# UNITED STATES PATENT AND TRADEMARK OFFICE

APPLICATION NO.	FILING DATE	FIRST NAMED INVENTOR	ATTORNEY DOCKET NO.	CONFIRMATION NO.
10/689,141	10/20/2003	Richard J. Gilpatrick	039189-9074	2779

The following correspondence is a non-final Office Action for application # 10/689,141, entitled: Frame for pressurized fluid apparatus, filed on 10/20/2003. Claims 1, 3-4, 6-12, 14-18, 21, 36, and 43-51 are pending.

FIG. 1

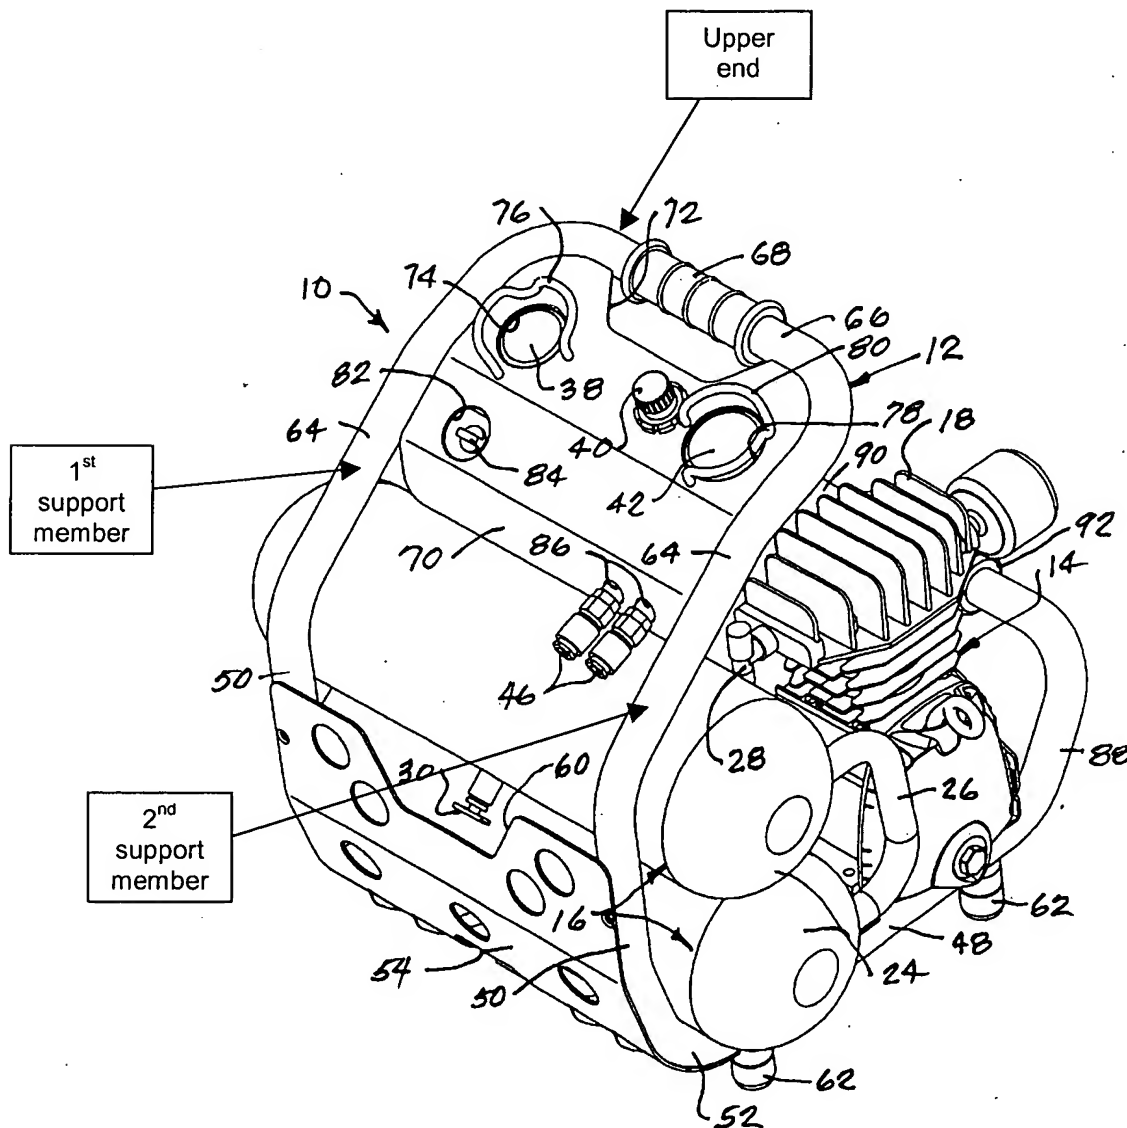
Regarding claim 1, Nolan discloses a frame, the frame comprising a base **48** that supports a power unit; at least one leg **62** that supports the base **48** on a surface; and a handle **66** configured to be used to move the frame from a first location to a second location, the handle **66** including an upper end, a first support member extending downwardly from the upper end, the first support member forming an acute included angle with the base **48** and a second support member extending downwardly from the upper end the second support member forming an acute included angle with the base **48**; where the first and second support members are integrally molded as one piece with the base **48** (as seen in Figs. 1 & 4 below).

Regarding claim 4, Nolan discloses the frame, where the base **48** includes an aperture therein configured to receive a portion of the power unit (as shown in Fig. 4 below).

With regards to claim 16, Nolan goes on to disclose the frame, where each of the support members forms an acute included angle with the base **48** (as shown in Fig. 4 below).

With regards to claim 43, Nolan discloses the frame, where the first support member has a first longitudinal axis and the second support member has a second longitudinal axis, where the first longitudinal axis forms an acute exterior angle with respect to the upper end of the handle **66**, and where the second longitudinal axis forms

an acute exterior angle with respect to the upper end of the handle 66 (see Fig. 4 below).

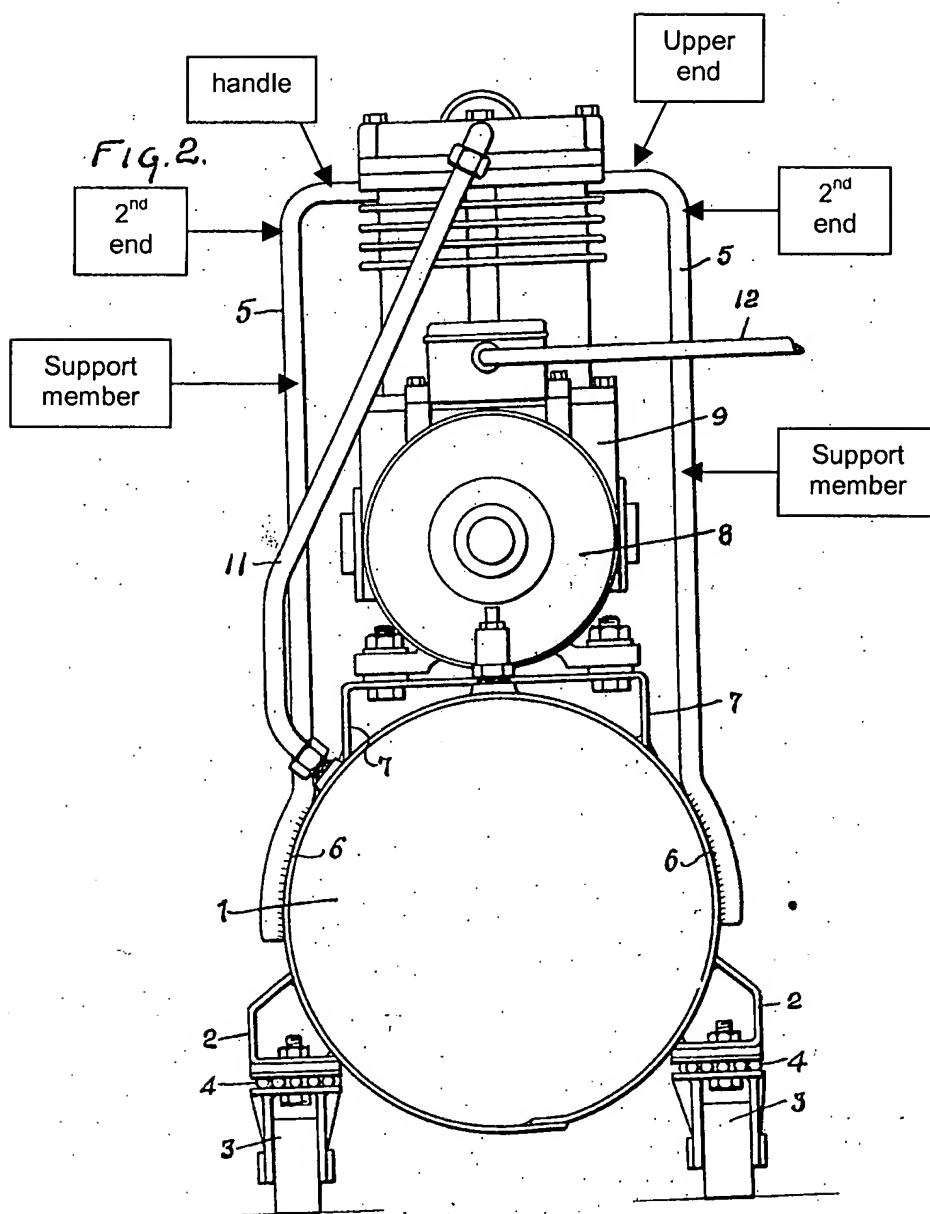
Regarding claim 46, Hobart discloses a frame comprising a base 1 that supports a power unit; at least one leg 2 that supports the base 1 on a surface; a handle configured to be used to move the frame from a first location to a second location, the handle including an upper end; and a pair of support members extending from the base 1, each support member having a first end 6 near the base and a second end near the upper end of the handle, where a first width between the respective first ends of the support members is greater than a second width between the respective second ends of the support members (as shown in Fig. 2 below).
